<b>Well Name:</b> PEAKY 9 8 STATE COM	<b>Well Location:</b> T17S / R29E / SEC 10 / NWNW / 32.8536164 / -104.0699264	<b>County or Parish/State:</b> EDDY / NM
<b>Well Number:</b> 20H	<b>Type of Well:</b> OIL WELL	<b>Allottee or Tribe Name:</b>
<b>Lease Number:</b> NMLC068722	<b>Unit or CA Name:</b>	<b>Unit or CA Number:</b>
<b>US Well Number:</b> 3001557602	<b>Operator:</b> SPUR ENERGY PARTNERS LLC

**Notice of Intent**

**Type of Action:** Plug and Abandonment

## **Peaky 9 8 State Com 20H P&A Procedure**

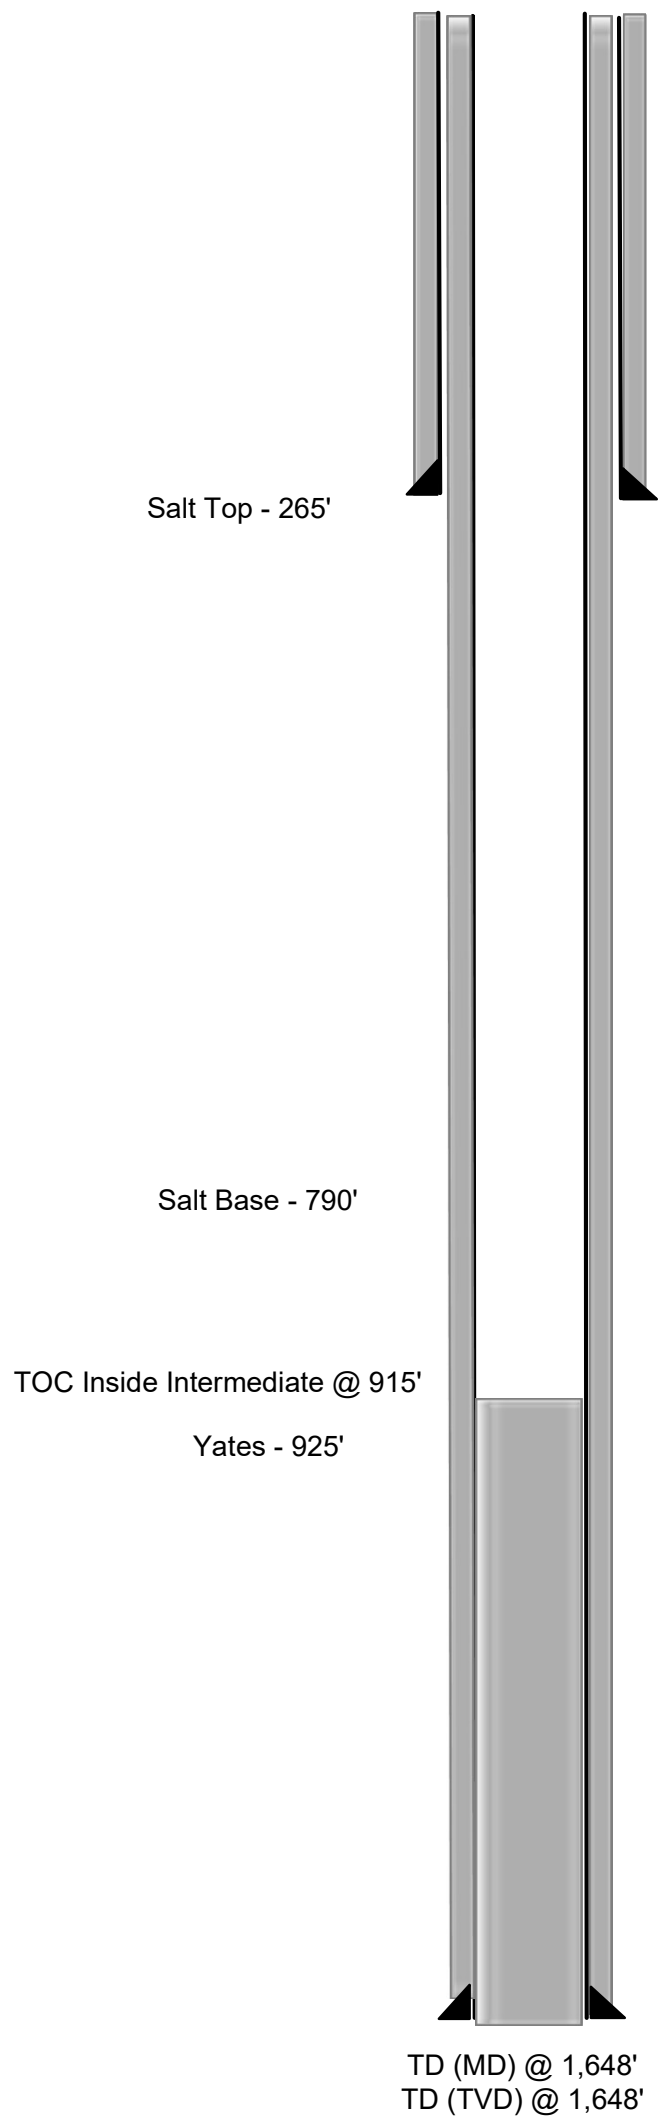
1. MIRU service unit & WL unit.
2. Pressure test casing to 500psi for 30mins. Run CBL from 915' to surface. **Review CBL with BLM.**
3. Plug 1: Spot 75 sxs Class C Cmt from 915' - **732'**. WOC and tag. (Yates, Salt Base)
4. Plug 2: Spot 120 sxs Class C Cmt from 315' - Surface. WOC and tag. (Surface Shoe, Salt Top)
5. Top off all annuli. Cut-off wellhead. Install above ground dryhole marker.

**APPROVED**

*By Saman Akhtarmanesh at 4:16 pm, Mar 11, 2026*
